**Section 16 Planning Application for Proposed Minor Relaxation of Restrictions of
Plot Ratio and Building Height for the Public Housing Developments at
Tung Chung Areas 133A, 133B and 133C
(Application no. A/I-TCE/4)**

**Proposed Minor Relaxation of Restrictions of Plot Ratio and Building Height for the
Public Housing Developments at Tung Chung Areas 133A, 133B and 133C**

Response to Comments

Figure 6

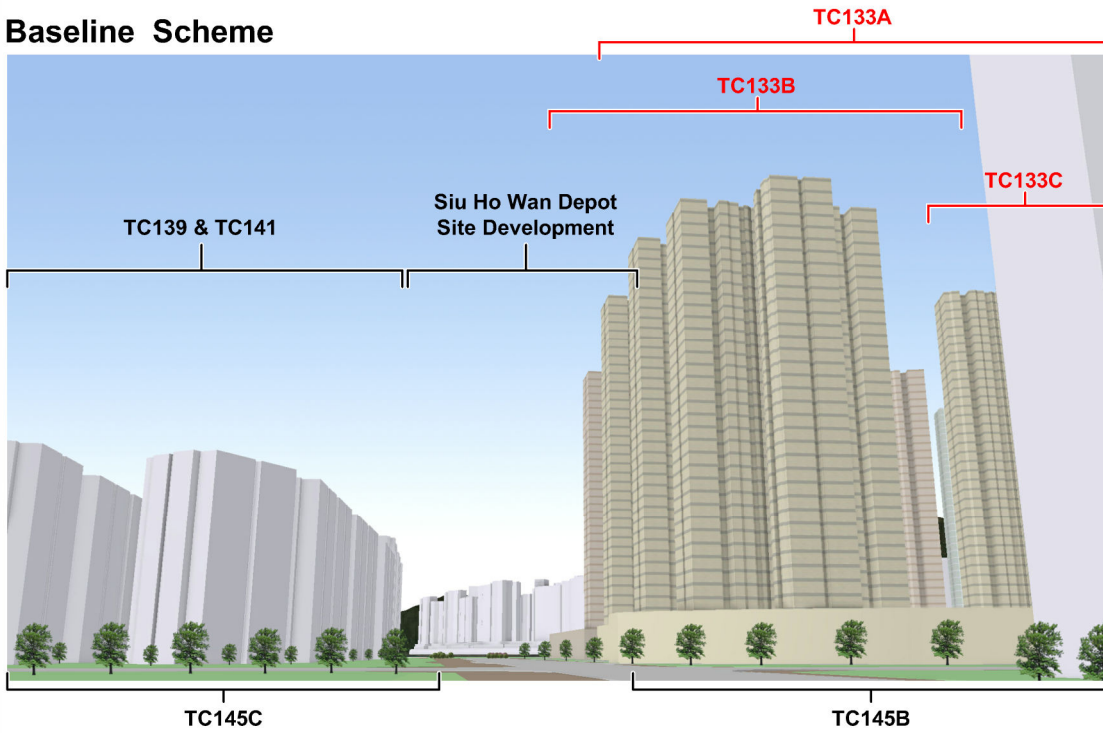
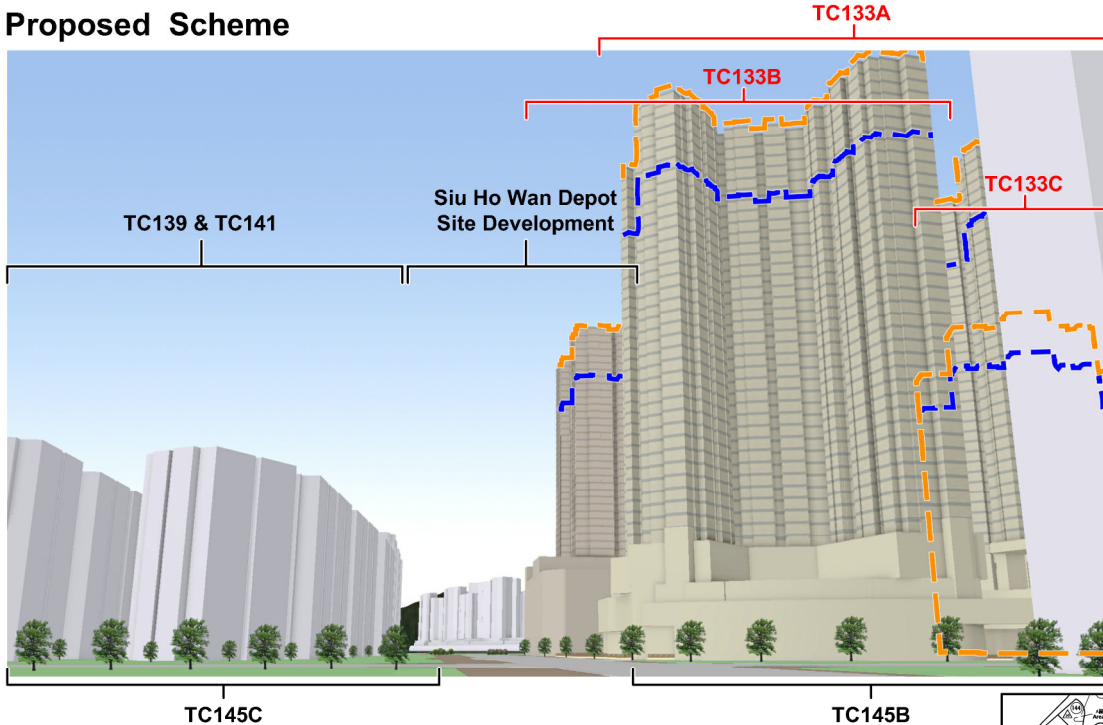
Comments	Housing Department's Response
1.	<u>Planning Department (Sai Kung & Islands District Planning Office)</u> (7 & 11.6.2024)	
	<p>Please provide the following supplementary info for our processing.</p> <p>Annotation on photomontages of VIA – please add (i) BHR under OZP to baseline scheme; and (ii) BH of proposed scheme; (iii) proposed level of BH relaxation;</p> <p>Definition and Function of Dedicated Pedestrian Zone (DPZ) and Justifications for including “O” zone (i.e. the DPZ”) into the development; and</p> <p>The GFA allocated for Social Welfare Facilities in (i) each of the Sites; and (ii) % of domestic GFA allocated for SWFs in the three Sites in total;</p>	<p>Relevant photomontages amended and attached.</p> <p>The DPZ is a 6.5m wide zone serves as an Emergency Vehicular Access (EVA) and pedestrian path, thus releasing more area for integrated open space and greening. The proposed DPZ does not count toward the plot ratio and local open space within the public housing developments. The DPZ is also accessible to public and could have function of open space.</p> <p>As agreed with SWD, about 5% of domestic GFA for each TC 133B and TC 133C would be allocated for Social Welfare Facilities (ie. TC133B approximately 5,800 sqm and TC133C 6,100 sqm) and no Social Welfare Facilities at TC 133A. The currently proposed Social Welfare Facilities would make up to about 2.3% of total domestic GFA of TC 133A, B & C three sites.</p>
